91-27

OFFICIAL NOTIFICATION UNDER THE U.S. FEDERAL BOAT SAFETY ACT

A. Required Water Separating Fuel Filter Replacement

MCM 7.4L Stern Drive Engines

71229

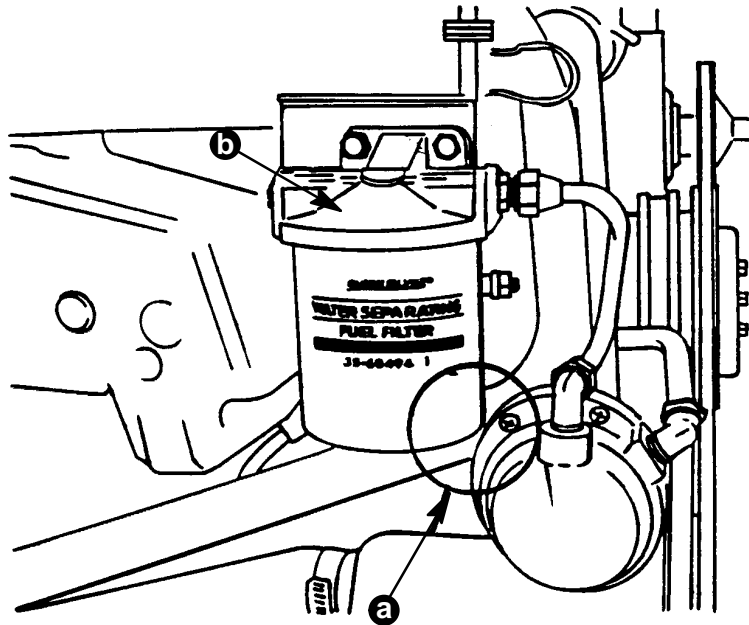
The fuel filter (Part Number 35-60494--1) may be touching the fuel pump. This situation was caused during the assembly of the engine. After a period of time, a hole will be worn into the bottom of the filter which in turn will allow fuel (gasoline) to leak into the bilge of the boat.

- a - Filter may wear through in this area
- b - Place Warning Decal Here

Look at part number on fuel filter. If the number (on filter) is 35-60494--1, the filter must be changed.

Change the filter on any engine that you have in stock. Install warning decal at location (b). If the boat has been sold, please contact your customer and perform this service on his engine(s). When an engine is registered at Mercury Marine, our computer will check to see if filter has been changed. If our records do not show that the filter has been changed, the customer will be contacted by letter with a campaign card enclosed. Please change filter and install warning decal. Use the campaign card to file for warranty.

- (1) 35-805269--1 Fuel Filter
- (1) 37-805349 Warning Decal

NOTE: This is the only filter that can be used on GM Generation V V8 engines because it is 1 in. (25mm) shorter.

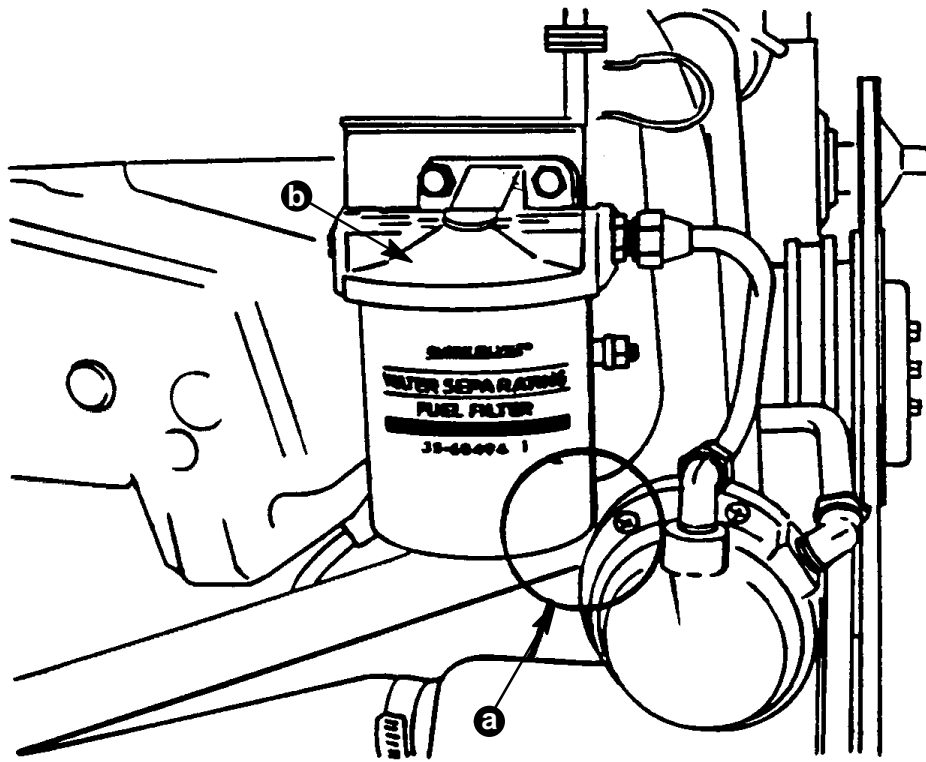
Mercury Marine has discovered that there may be insufficient clearance between the fuel pump and water separating fuel filter on your engine. Insufficient clearance can allow the filter to rub on the fuel pump. If it does, a hole could be worn through the filter and result in a fuel leak. A leak would create the potential for a fire or explosion if an ignition source is present. Mercury Marine has developed this recall program to eliminate any such risk or concern.

- a - Filter may wear through in this area
- b - Dealer to place warning decal here

Enclosed with this letter is a recall campaign card and a warning decal. Your local MerCruiser dealer can install the decal and a new, shorter fuel filter designed to provide greater clearance and eliminate the possibility of a fuel leak. Please have your dealer refer to Service Bulletin 91-27. To accomplish the replacement, please take the following steps:

Installation of the decal and replacement fuel filter can normally be done in one half hour or less, but it is important that the filter be dealer installed since improper installation could result in fuel leaks. Until the new filter is installed, use the drawing included with this letter and check your fuel filter for signs of wear. Always make sure to run your bilge blowers before starting the boat.
